**MONTGOMERY COUNTY PLANNING DEPARTMENT**  
THE MARYLAND-NATIONAL CAPITAL PARK AND PLANNING COMMISSION

**MEMORANDUM**

**REVIEW TYPE:** Site Plan Amendment  
**CASE #:** 81999002G  
**PROJECT NAME:** Downtown Silver Spring-Civic Building and Town Square

**ZONE:** CBD-0.5  
**APPLYING FOR:** Approval of Parcel B, Block A of the Downtown Silver Spring – IVP Urban Renewal Plan to include approximately 41,986 gross square feet of new development for a Civic Center and 136,930 gross square feet of on-site public use space, including an outdoor seating area, pavilion, and ice skating rink .

Illustrative of ice-rink replaced by a civic green

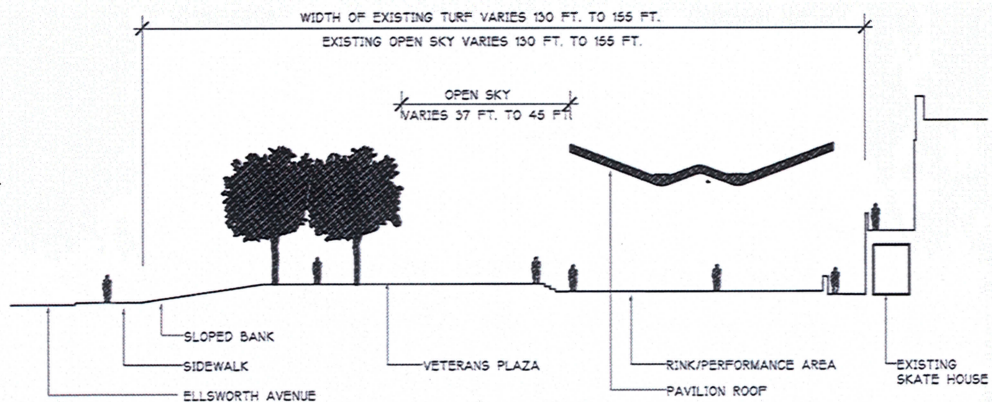
Those in opposition to the proposal believe this is an over design of the space, citing to the current fondness for the artificial turf and the non-programmed nature of the green space, which has brought together a variety of users, especially teens and families.

The previous slide plan view drawing below are illustrative drawings by a resident indicating potential interruptions or obstacles to the open sky with dimensions
